REFERENCE:	Nova Bus Manuals
SECTION:	18 Articulation system
RS N°:	MQR 7621-528
EFFECTIVE IN PROD.:	L584

SUBJECT:	Articulation platform rubber trim
JUSTIFICATION:	Probable lateral displacement of the articulation platform rubber trim.

Figure 1 - Floor Cover to Detach

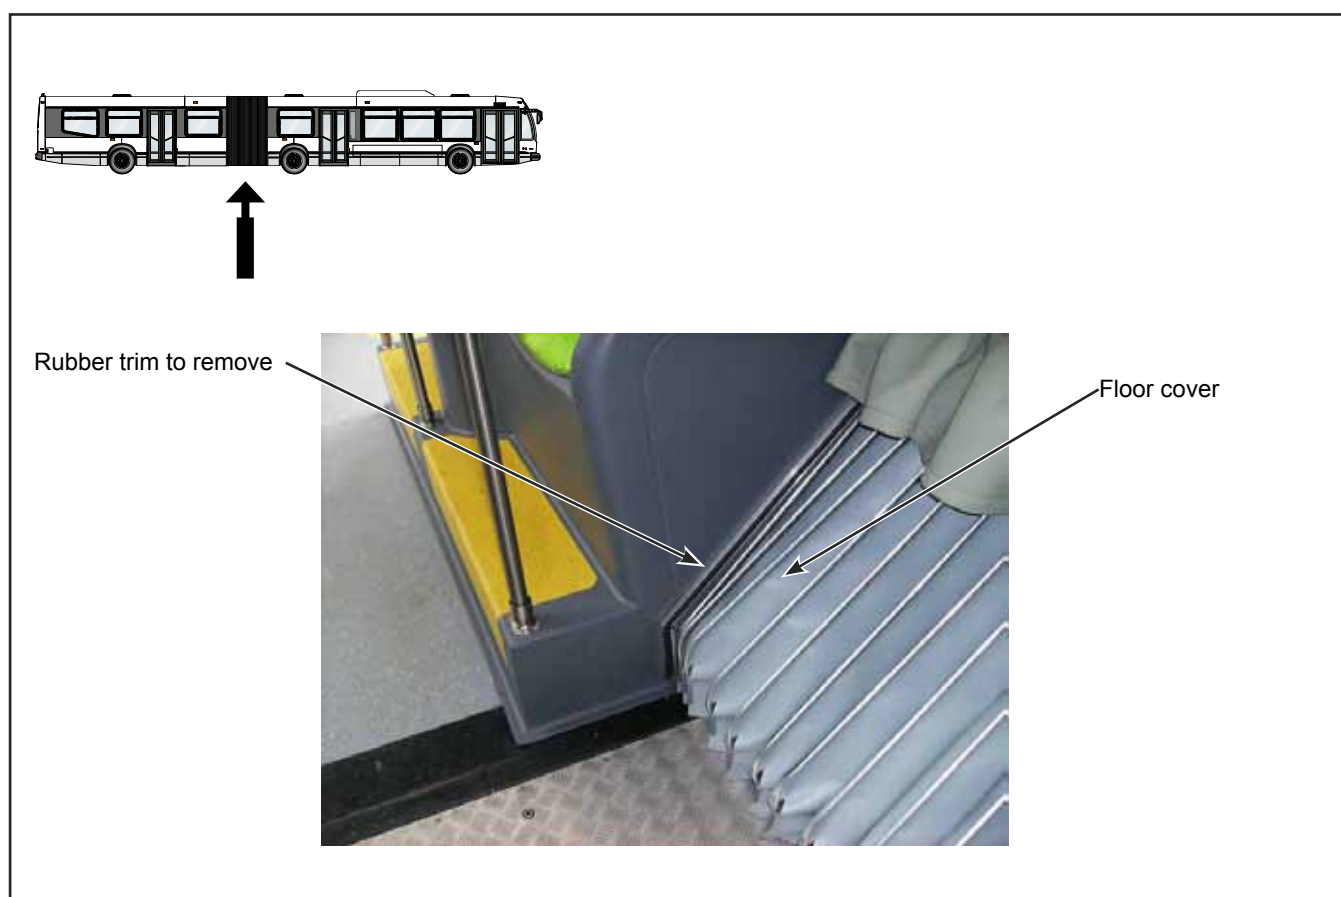
1.1. Detach the floor cover attached to the side of the four-seat installation. See Figure 1. Retain the rubber trim.

Figure 2 - Washers to be Replaced

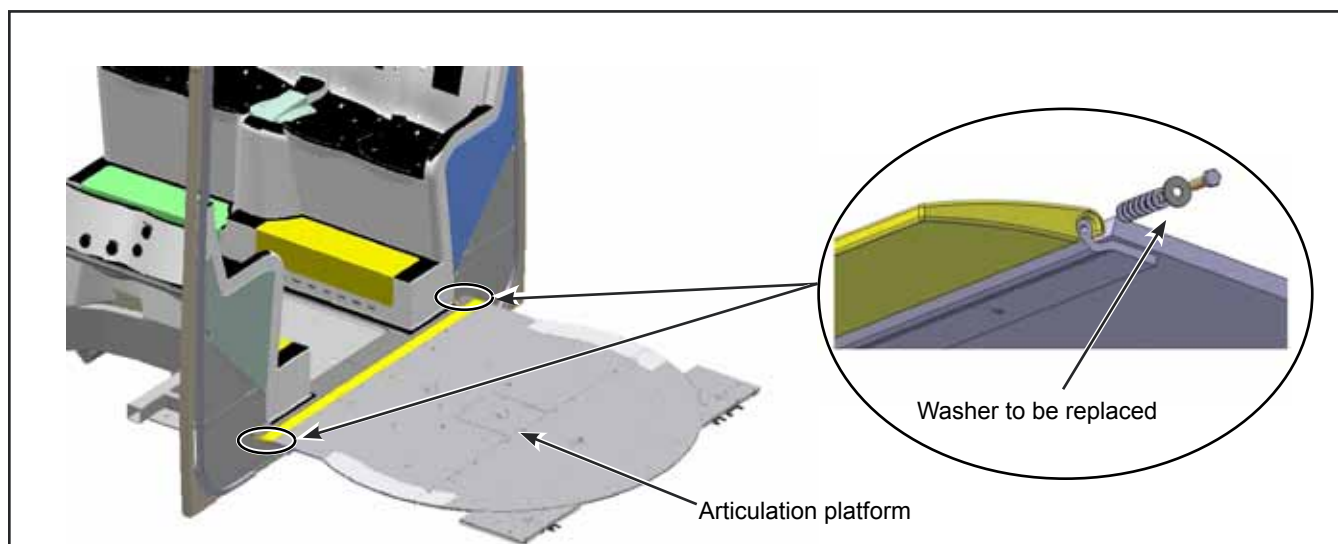
- 1.2. Remove the bolt with the washers. See Figure 2. Retain the hardware, except the 5/8 in (15 mm) washer, which must be discarded.

- 1.4. Install the retained hardware, replacing the 5/8 in. (15 mm) washer with a 1 in. (25.4 mm) washer N64081. See Figure 4.

Figure 3 - Typical Space Between Floor Trim

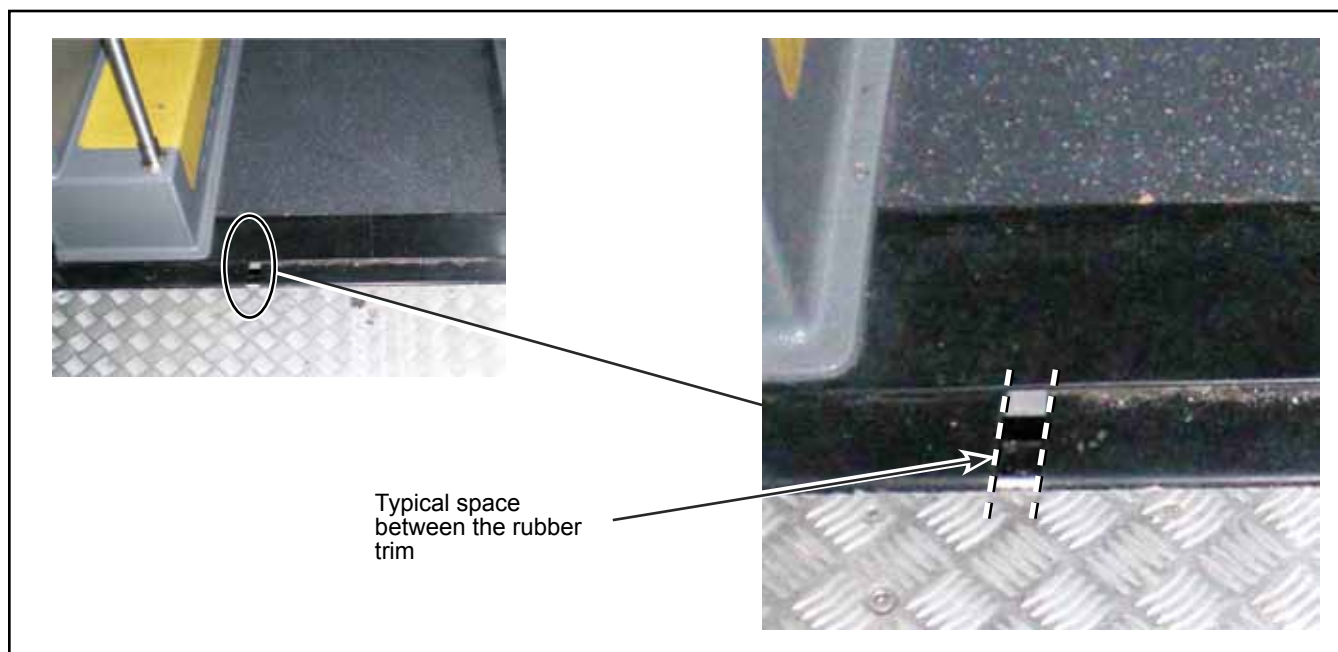
- 1.3. If required, replace the floor trim to eliminate any gap in the joints. See Figure 3.
